City of Portland, Oregon
Bureau of Development Services
Land Use Services
FROM CONCEPT TO CONSTRUCTION

STAFF REPORT AND RECOMMENDATION TO THE DESIGN COMMISSION

CASE FILE: LU 16-163126 DZM AD
PC # 15-221480
SW 3rd & Taylor
REVIEW BY: Design Commission
WHEN: August 4, 2016 @ 1:30pm
WHERE: 1900 SW Fourth Ave., Room 2500A
Portland, OR 97201

3RD & TAYLOR / PORTLAND, OR
C.13 ELEVATION - EAST (SW 2ND)

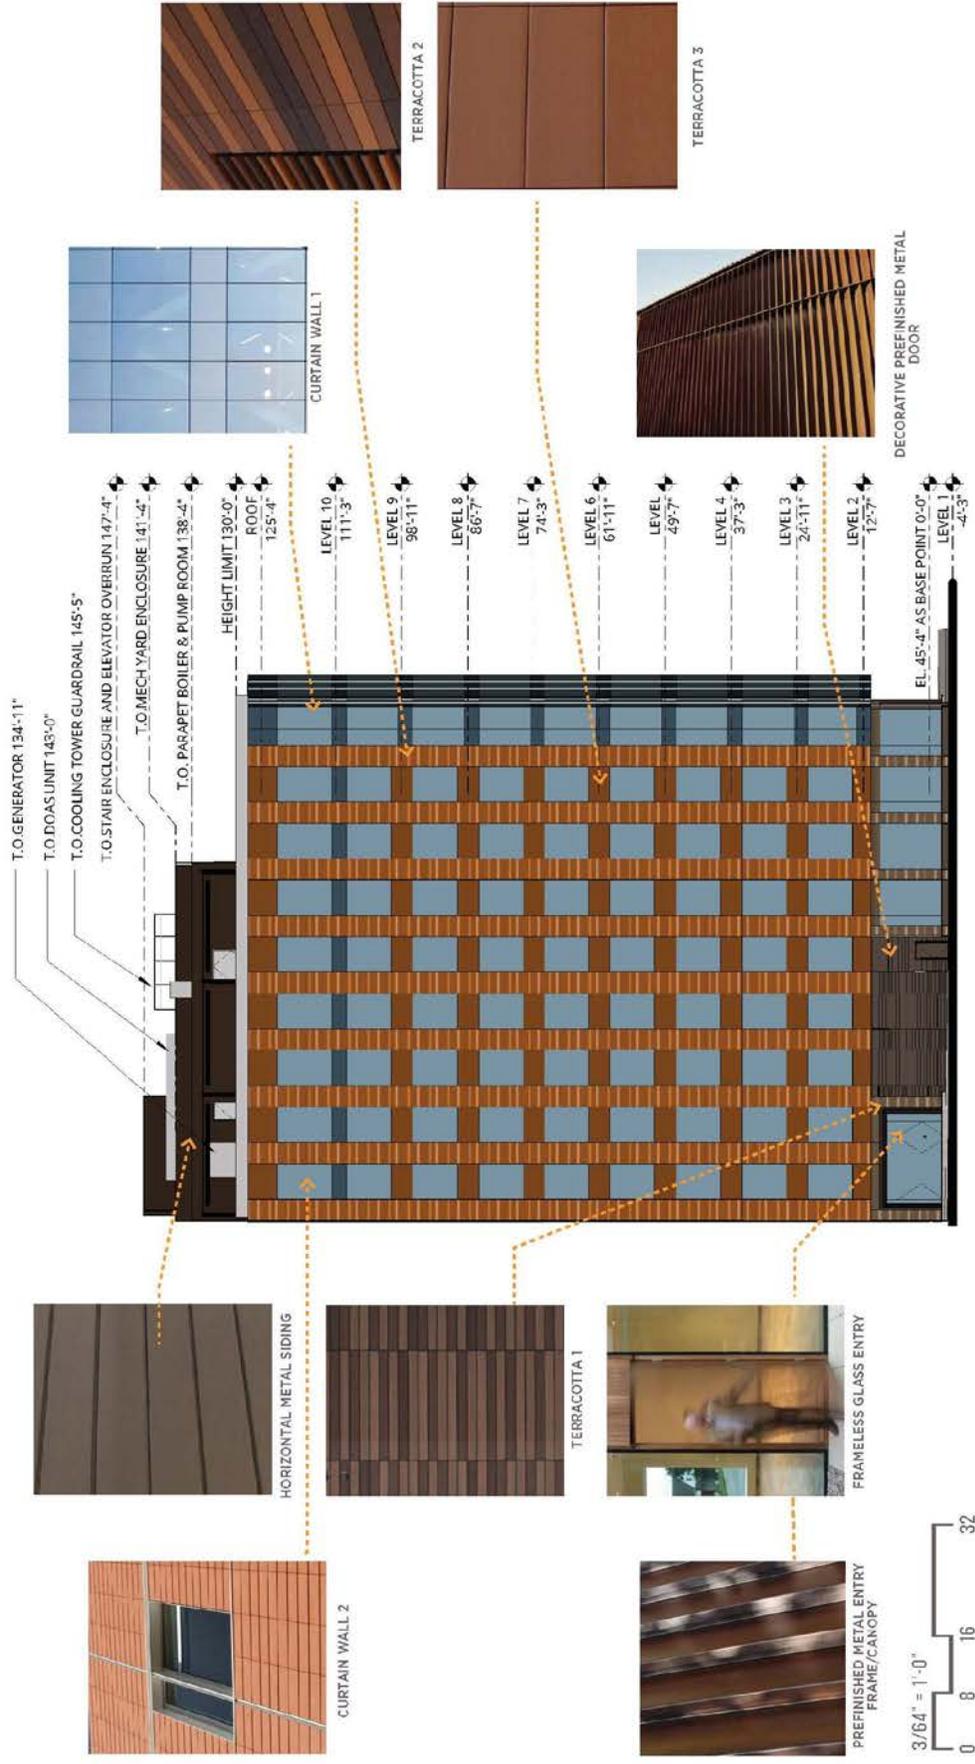
Findings: The majority of the ground level is devoted to active uses including retail, office lobby, and a bike commuter lounge. The ground level features large storefront windows separated via a consistent rhythm of terra cotta pilasters. The building is slightly set back from the street lot line allowing opportunities for the ground floor retail spaces to spill out onto the sidewalk without obstructing the path of passing pedestrians. The primary office entry is wide and generous with an illuminated sawtooth portal drawing people into the building. Other entrances are also recessed into the ground floor building wall with illuminated sawtooth portals and the locations of potential future entrance locations are identified. While entrances appear to be provided on each frontage, the SW 2nd Avenue entrance, which is a transit street, is shown to be a single solid metal door and therefore cannot be considered a primary entrance; as such, a Modification to 33.130.242 Transit Street Main Entrance is required. Staff does not believe that a Modification to this standard is justified as a primary entrance on this façade would provide convenient access to the corner retail space from SW 2nd Avenue and would balance the inactive area of the garage entrance. In addition, an entrance can be

This guideline is not yet met, however, with the introduction of a glazed door with the same treatment as other retail entrances on the SW 2nd Avenue façade, this guideline could be met.

All mechanical equipment is located on the roof with louver vents proposed above the storefront glazing. The aesthetic of the louvers is carried down to the sidewalk at both the garage gate and the loading gate, resulting in a cold and unfriendly

ground level façade for approximately 28' on the east façade at the garage entrance and adjacent retail door and for approximately 20' on the west façade at the loading bay. A larger louver is proposed above the loading bay resulting in a rather large louver aesthetic immediately adjacent to the landmark Auditorium Building which has a well-established pedestrian-friendly aesthetic.

proposes a single opaque metal door on the SW 2nd Avenue façade leading to the corner retail space; this does not qualify as a main entrance, therefore, a Modification is required. Staff has noted above that because of the design of this entrance, unlike the other entrances which are highlighted with illuminated sawtooth portals and clear doors, this entrance is unlikely to be used except as an egress, and therefore guideline A8 *Contribute to a Vibrant Streetscape* is not met. Staff finds that neither the purpose of the standard is met nor are the guidelines better met by the proposal.

This Modification does not warrant approval; staff suggests that the SW 2nd Avenue entrance be redesigned so that a Modification is not required.
